Report to the Future Melbourne (Planning) Committee

Ministerial Referral: TPM-2016-27 557-591 Swanston Street, Carlton

PLANNING REPORT

Figure 8: Access & Circulation Plan (Source: Carlton Brewery Masterplan, October 2007)

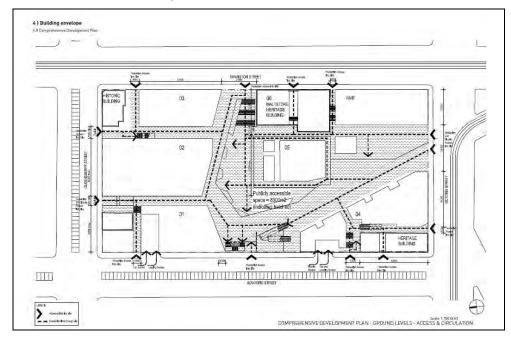
- 92. The Building Envelope Plan (Comprehensive Development Plan Building Envelope, p55 of the Masterplan) shows a 14.5m separation to the Maltstore building, and does not show level changes. When read in conjunction with the Ground Levels plan (Comprehensive Development Plan – Ground Levels- Access and Circulation, p56 of the Masterplan), the level changes are shown and the separation distances differ. The Masterplan anticipated a ground level separation of 21.66m between the southern side of Building 3 and the Maltstore building, as shown below.

93. Above ground level the building is shown to overhang this additional 7m setback (to Level 9, as per Level 6-50 plan, p 82).

- 94. The Masterplan shows space provided at ground level to allow the functions and elements outlined within 'Section 3.7 Courtyards' as detailed above. In the absence of further details of the wintergarden design from the applicant, it appears that the 14.5m space is inadequate to provide a suitable landscape batter, stair access to the lower level, and plaza space/east link as identified in the Masterplan.

- 95. It is unclear how the wintergarden would relate to the other areas of the east west link, or to the internal open space (the Forum) as shown within the Masterplan. The plans and supporting information do not contain context with regard to the publicly accessible walkways and courtyards, do not indicate whether the intention for the lower level open space and access provisions across the former CUB site have been altered or changed or are no longer required.

- 96. While there would be no 'in principle' objection to a change to the width of the wintergarden, it needs to be shown as suitable to achieve the aims of the Masterplan. This includes: to provide a through-block link to Bouverie Street along the East-West axis, and to provide stairs to the lower ground level Forum (if this is still intended to be constructed). Should the space be shown to be inadequate for these functions, the proposal would not be acceptable, and would potentially be considered as not 'generally in accordance with' the CDP and Masterplan.

- 97. The proposed wintergarden design cannot be supported at this width in the absence of further contextual information.
- 98. This matter should be resolved by the applicant through the submission of further details on the wintergarden and its intended links through the site, outlining any departures from the Masterplan.

Massing image along Swanston St – Source: VCAT Amended plans

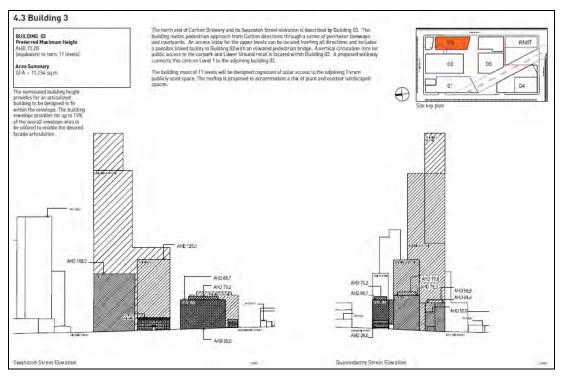
The proposed building to AHD 97.4 exceeds the nominal height in the CDP and Masterplan by 24.2m. In addition, the building breadth has been increased at ground level through the deletion of the 4.5m wide through block link to the north side of Building 3, as shown on the Masterplan.

Whilst the sky garden is a positive inclusion to provide some relief, we require further depth and massing articulation of this surface in lieu of reliance on surface effects. We have a similar critique of the upper component of the form, which appears intentionally flat with flush windows reinforcing the sense of a monolithic block. Whilst this technique has been deployed in more slender built form by DCM, its application in this broad slab-like form is highly problematic, and lacks any relationship to built form within its surrounding Swanston Street context.

The recently approved and under construction 599 Swanston Street offers a helpful counterpoint, where Hayball and Urban Nest worked closely with CoM to develop a clustered vertical form in order to offset a similar proportioned slab envelope, in conjunction with a tactile, brick base element which responded to the scale of the retained corner heritage form. We would

strongly recommend a more vertical, granular approach to the arrangement of this considerable mass, in lieu of the current slab arrangement.

While it is acknowledged that there is discretion afforded to the overall height and mass of the building in this location within the CDP and Masterplan, the proposed height and form is not considered to be an acceptable design response and does not meet the design objectives and outcomes sought by the CDP. In particular the proposal is considered to fail to provide a suitable transition in height from the Central City to Carlton built form.
